Attachment 2 - PLN17/0213 - 3 Park Crescent Alphington - Engineering comments 1 of 2

To: Michelle King
From: Artemis Bacani
Date: 25 January 2018
Subject: **Application No:** PLN17/0213
Description: Construction of a Second Dwelling and Works Associated with the Existing Dwelling
Site Address: 3 Park Crescent, Fairfield

Attachment 5 - PLN17/0213 - 3 Park Cr Fairfield - Open Space Referral (2)

Subject: PLN17/0213 – 3 Park Crescent Fairfield

Proposed Upper Floor Plan & Carport

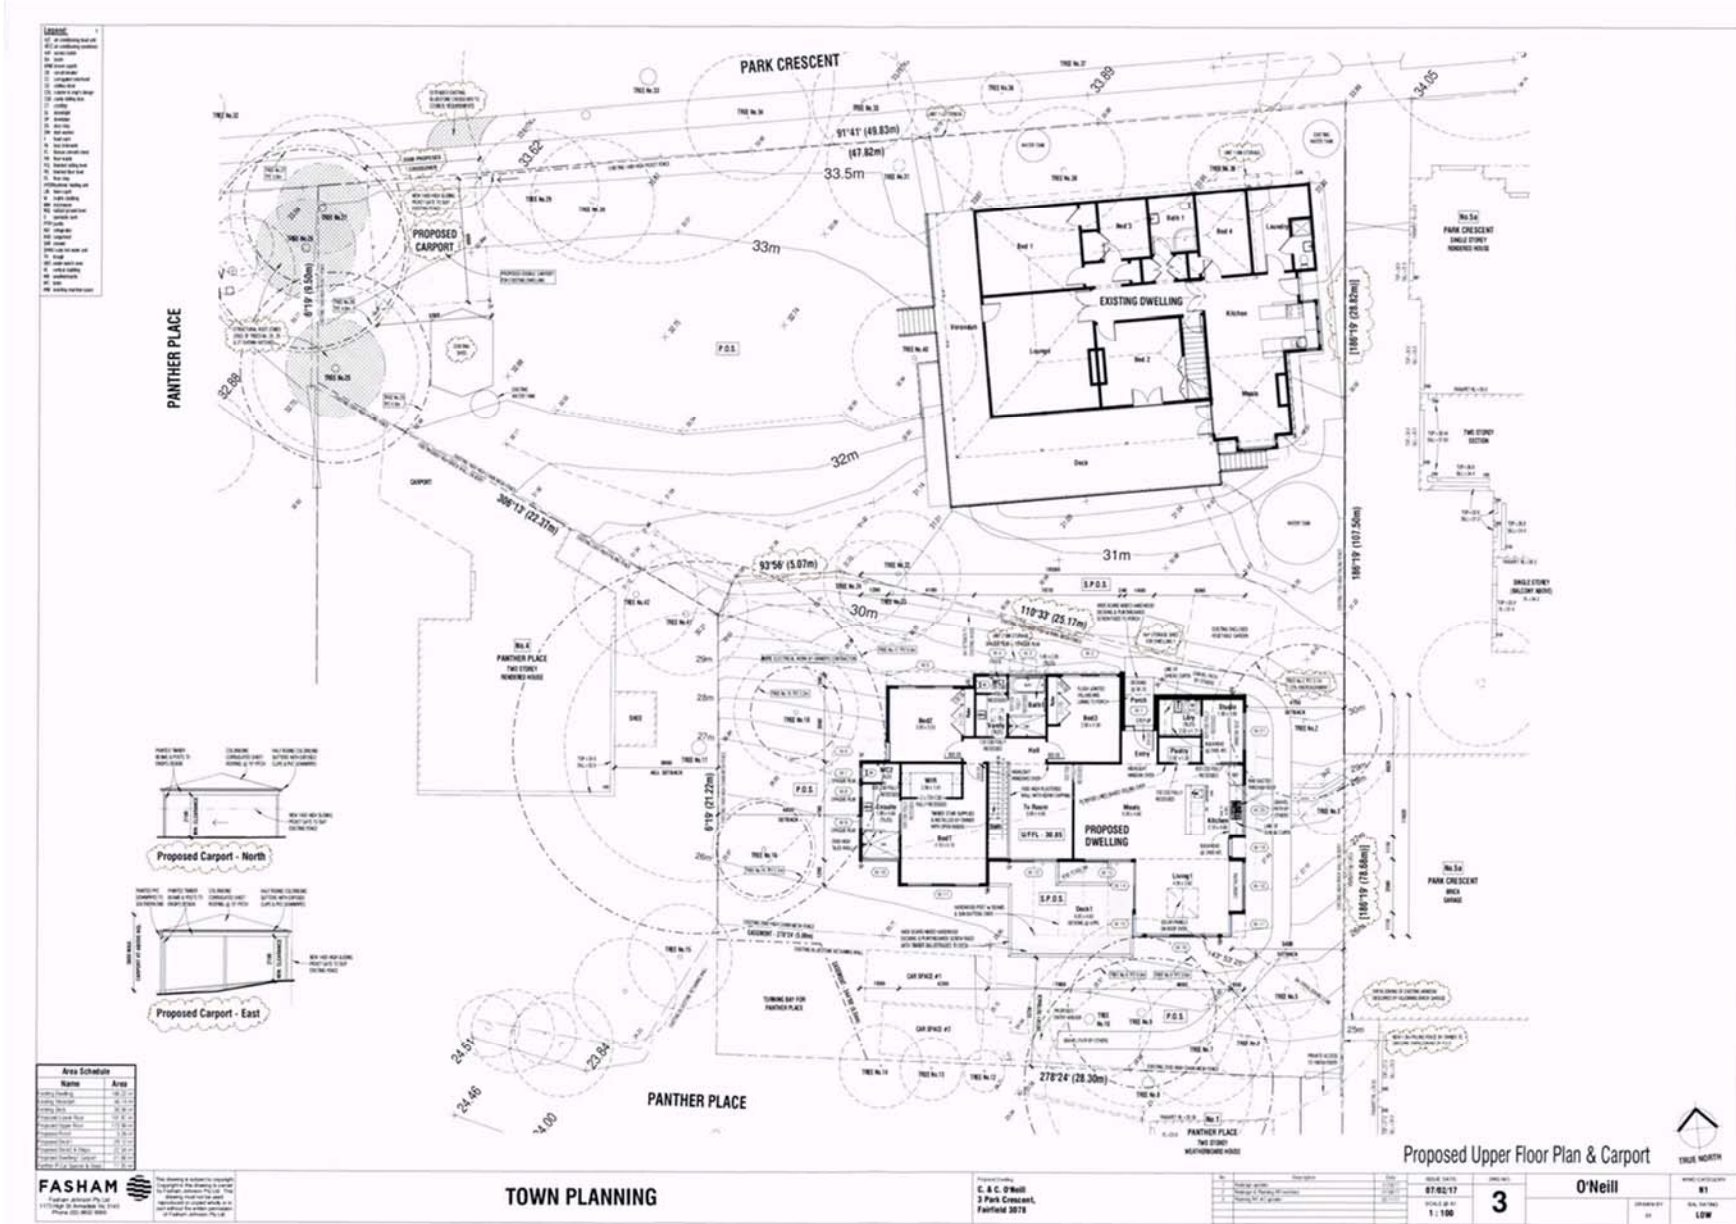
Item	Assessment
Access Arrangements – Park Crescent	
Carport Entrance	The entrance width of the carport is not dimensioned on the drawings.
Headroom Clearance	A headroom clearance of 2.1 metres has been provided which satisfies <i>Design standard 1 – Accessways</i> of Clause 52.06-9.
Vehicle Crossing	A site inspection revealed that the existing vehicle crossing is approximately 3.4 metres. The applicant proposes to widen the vehicle crossing to 5.5 metres.
Access Arrangements – Panther Place	
Vehicle Access off Panther Place	Vehicle access into the existing car spaces is via an easement which is used by residents to perform a U-turn.
Entrance Width of Open Car Space	The oblique width of the car space entrance is approximately 5.5 metres.
Car Parking Module	
Internal Dimensions of Carport	The unobstructed internal dimension of the carport must be dimensioned on the drawings.

Item	Details
Carport Entrance	The entrance width of the carport must be shown on the drawings.
Internal Dimensions of Carport	The internal dimension of the carport must be shown on the drawings.
Open Car Space	To be fully dimensioned on the drawings.
Street Tree – Park Crescent	The applicant must liaise with Council's Open Space unit regarding a street tree which appears to be in the area of the widened vehicle crossing. The applicant must obtain advice on the lateral clearance that is required for the new vehicle crossing. All costs associated with the relocation/removal of the tree will be the responsibility of the Permit Holder.

Carspace path analysis

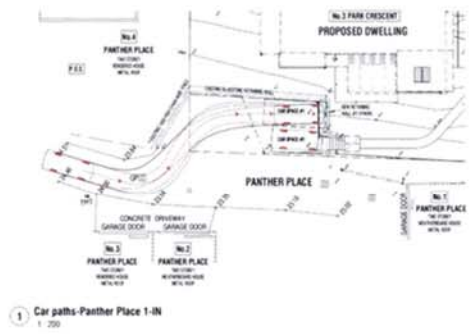
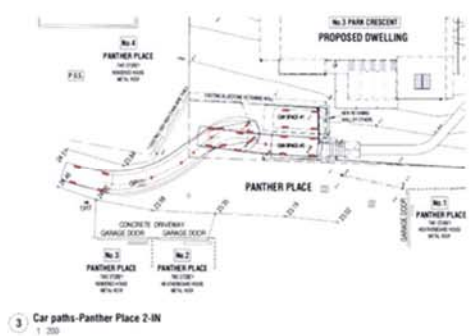
Item	Assessment
Car Parking Module	
Internal Dimensions of Open Car Space	<p>The car space has an internal width of approximately 4.85 metres. The northern boundary of the car space has a length of approximately 7.57 metres and the southern boundary is approximately 5.95 metres.</p> <p>The width of the car space is suitable to accommodate one B85 design vehicle.</p> <div data-bbox="584 600 1307 1153" style="border: 1px solid #add8e6; padding: 10px; text-align: center;"> </div> <p style="text-align: center;"><i>Figure 1</i></p>
